# Class Rule Changes

International Speed Windsurfing Class Association

Effective Date: 2024 March 01

Status: Approved

**FIG A** reports the National Letters, Sail Numbers and Class Insignia approximated position.

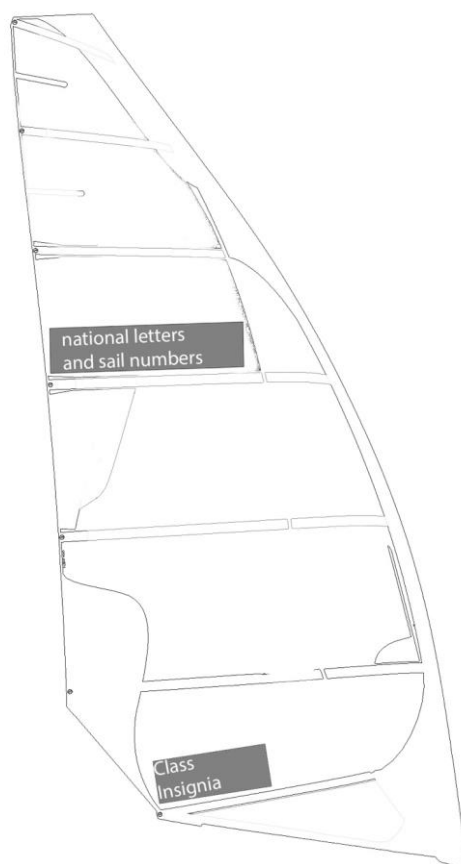
RRS Appendix B.9, G.1.1(a), G.1.2 and G.1.3 are changed as follows.

- (a) The **sail** shall carry the National Letters and Sail Numbers as specified in FIG A below. The height of characters and space between adjoining characters on the same and opposite sides of the sail shall be as follows:

- (b) For World Championships and Continental Championships, the class insignia shall be placed on the **sail** as specified in FIG A below. The Class Insignia shall comply with the following specifications:

Minimum height	170 mm
Minimum space between characters and from edge of sail	15 mm

Minimum width	150mm
Minimum height	120mm
